Howlong Sand and Gravel Expansion Project

Submissions Report

State Significant Development 17_8804

February 2022

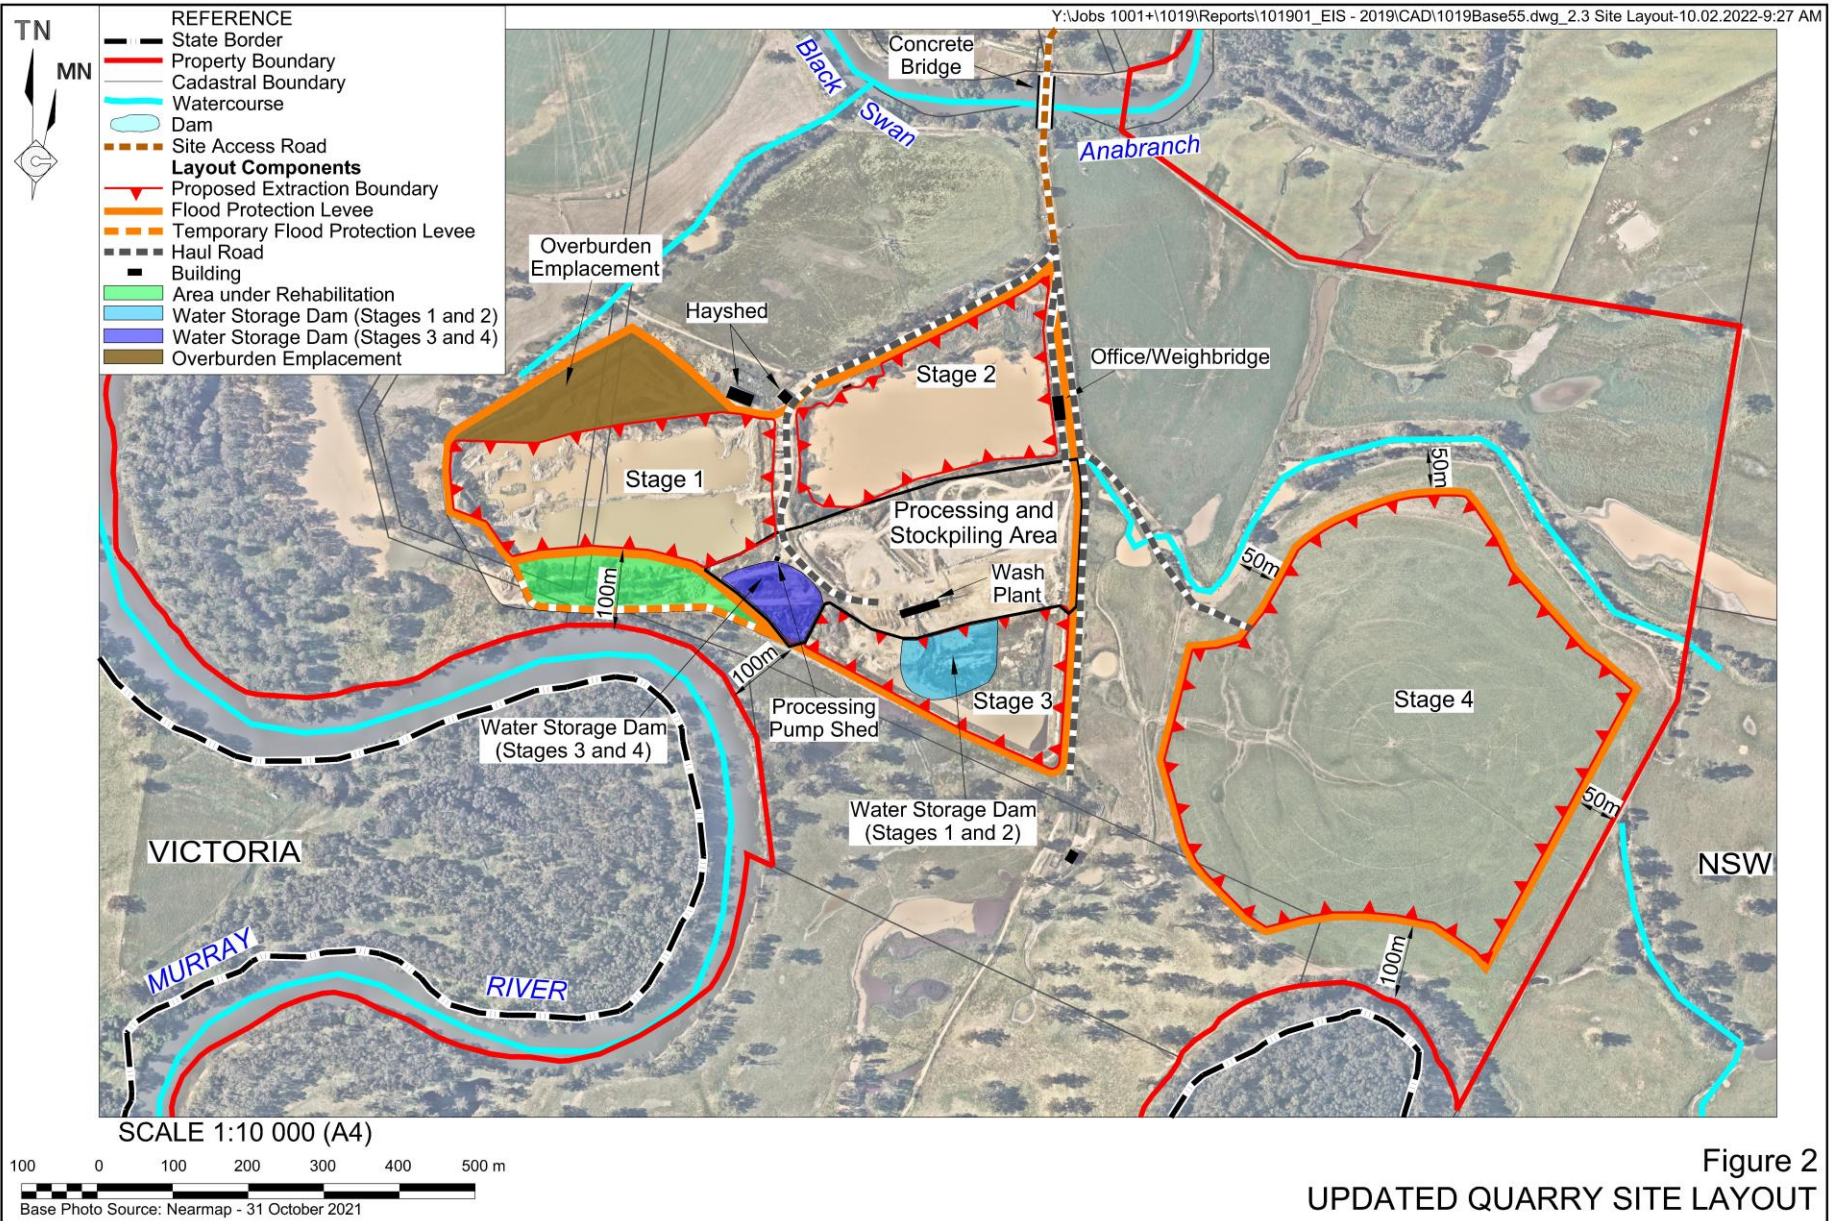
Several minor refinements to the Quarry Site layout have been made in response to the recommendations in Government agency feedback. Principally these relate to water management within the Quarry Site. The updated Quarry Site layout is presented in **Figure 2**. In summary the refinements to the layout have included the following.

2. The flood levee in the Stage 1 extraction area has been realigned to closely follow the extraction limit and incorporate the overburden emplacement area. The original alignment would be constructed initially in the southwest corner for the duration of works required to reclaim the section of the Stage 1 extraction area that would constitute the 100m buffer between operations and the Murray River. After this time the levee would be removed and established at the extraction area boundary. The realignment is discussed further in Section 4.1.5.8 in response to the Department of Planning Industry and Environment - Water (DPIE-Water) recommendations for the Project.

The flood levee has been re-aligned to follow the extraction boundary in the southeastern corner of the Stage 1 extraction area (see **Figure 2**). It is proposed that the levee be constructed to the previous alignment while land reclamation occurs, after which time it would be removed and relocated. Both the temporary and permanent alignment are presented in **Figure 2**. This would ensure that operations in the Stage 1 extraction area are protected by the levee while these works occur, but that the final alignment reflects the final boundary of disturbance and the proposed wetland. The flood levee has also been re-aligned on the northern side of the Stage 1 extraction area to incorporate the overburden emplacement area.

Figure 3
WATER SOURCE AND USE SCHEMATIC

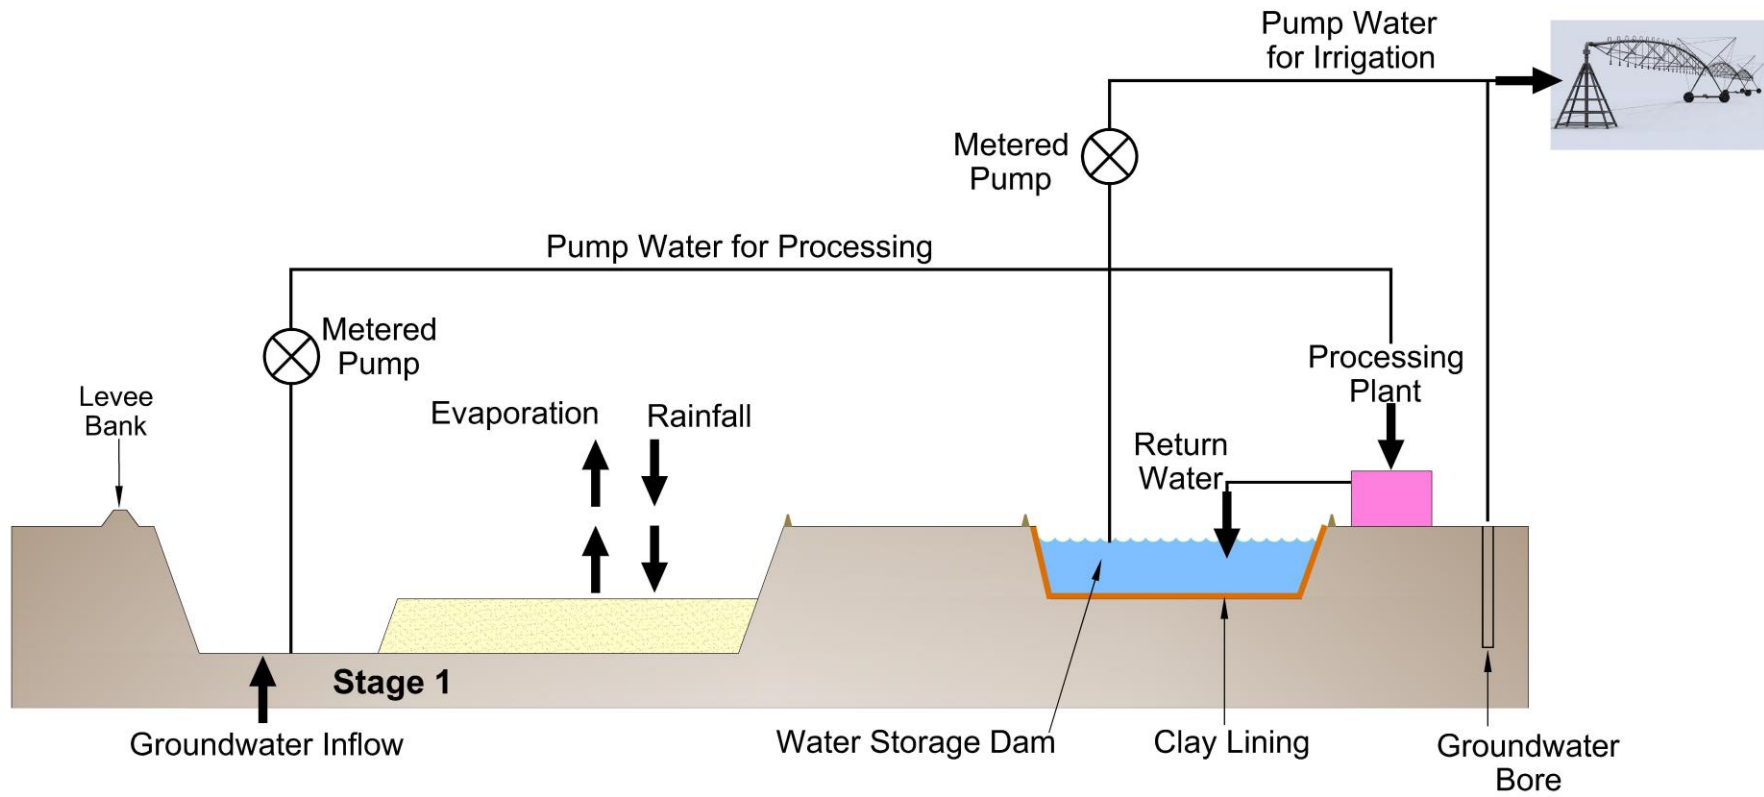
3. A Water Storage Dam would be developed initially in the vicinity of the Stage 3 extraction area and then relocated to the northeast to accommodate extraction activities from Stage 3. The Water Storage Dam would be a clay-lined turkeys nest style dam. This water management infrastructure is required to reduce the licensed water take for the Project and avoid effective double-counting of water removed from the active extraction area and then used for irrigation. The rationale for this change is discussed in more detail in Section 4.1.5.2 in response to the DPIE-Water recommendations for the Project. An updated water source and use schematic figure is presented as **Figure 3**.

Figure 10

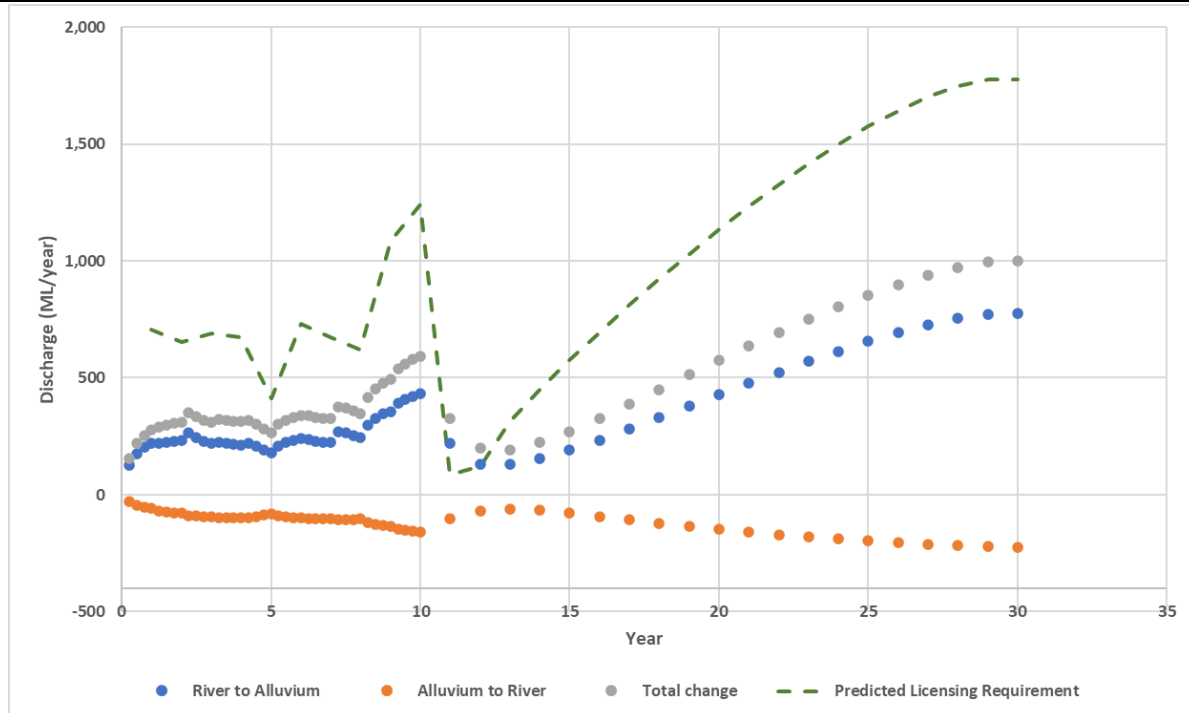
Figure 10 presents the predicted water access licensing obligations, modelled river inflows from the Shepparton Formation to the Murray River, the modelled river outflows to the Shepparton Formation and the calculated nett loss over the Project-life.

Review of **Figure 10** identifies that on an annual basis, the Project would locally increase flows from the Murray River to the Shepparton Formation whilst concurrently reducing flows in the opposite direction. As extraction operation progress, the discharge from the river increases to a peak of 591 megalitres per year (ML/year) in Year 10 of operations (refer Table 7-1 of Water Technology [2022]). Following Year 10, the annual rate of discharge from the Murray River to the Shepparton Formation is predicted to decrease to 195ML/year before steadily increasing to peak at 1 002ML/year in Year 30. The nett loss clearly correlates with the Project's predicted licensing requirements, although in Years 11 and 13, there is a slight lag apparent between the predicted licensing requirements and nett loss.
